***ELECTRIC CHAIN GRIDDLE
ECGM SERIES***

ECGM-24S, ECGM-36S, ECGM-48S, ECGM-60S

PARTS LIST

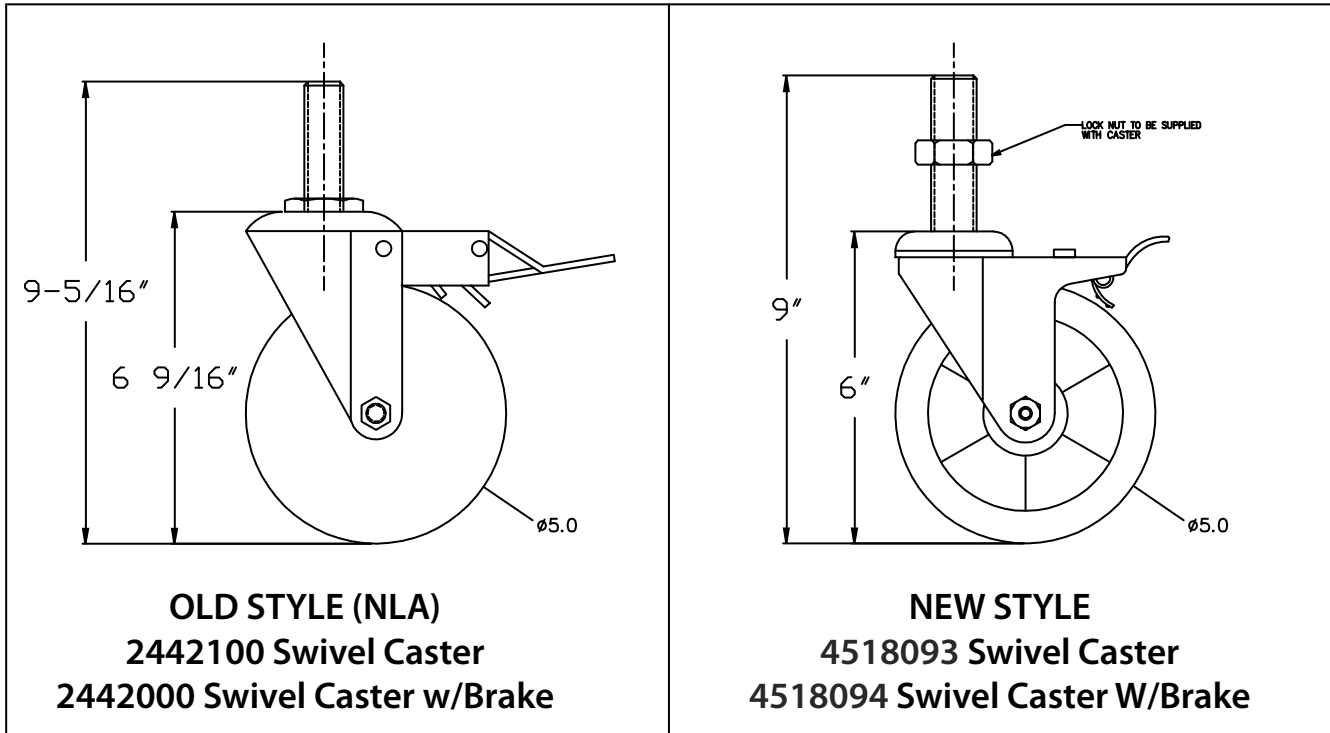
Please note that there are differences between the old and new casters, The new casters are .312" (5/16) shorter overall so in this case, would not be interchangeable. When replacing the old caster Garland highly recommends replacing all remaining casters with the new caster. both new and old casters use (5") diameter wheels.

First unit manufactured with the new casters:
Model: CG-72R-0004
Serial Number: 0410100108836
Implementation Date: October 25/2004
